NCC Pathway intersections with minor roads

Giving pathway users the priority over
motor vehicles: Sir John A Macdonald
Parkway Waterfront Linear Park

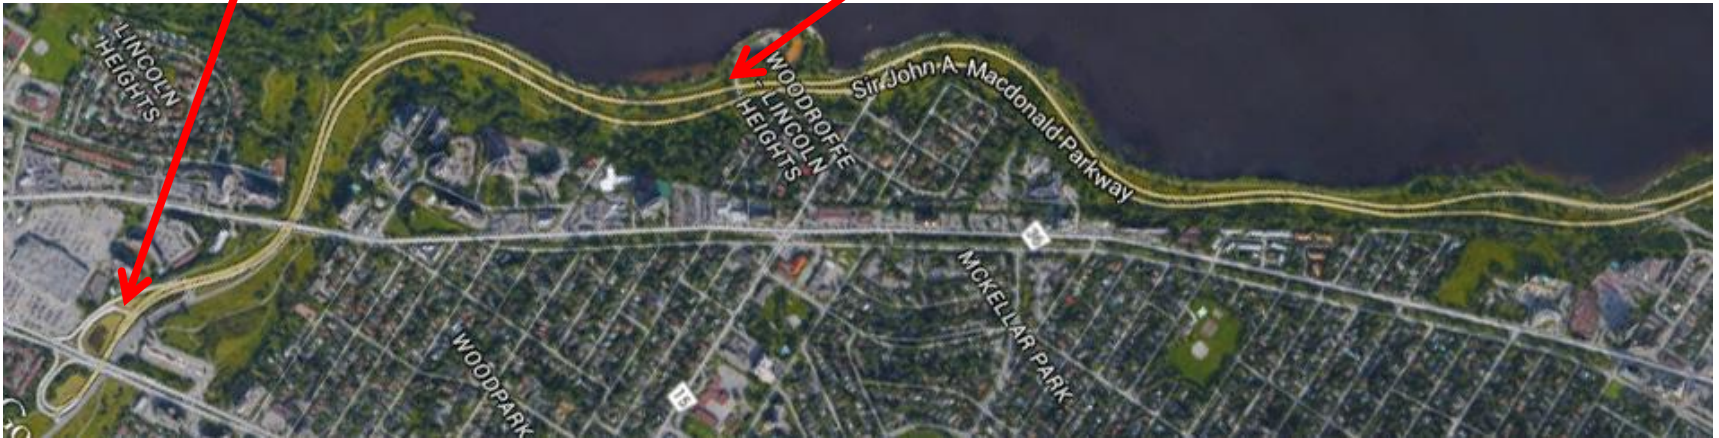
- Where the pathway meets a minor road, make all vehicles (cars or bikes) on the road stop
- In certain cases, use a 'speed table' (raised intersection), so that vehicles have a 'hump' to get over, encouraging compliance with the stop sign
- Permit the cyclists to cross the road without stopping, and, due to the speed table, without having to drop down to road level. (No curb 'bump'.)

- Make them, provided that:
 - Sightlines are sufficient (or can be made so) for motorists to see fast-moving cyclists before proceeding across path
 - There is sufficient storage space for vehicles inbound to parking lot to queue up without fouling the SJAMP
 - Speed table may not be practical for certain plowed roads
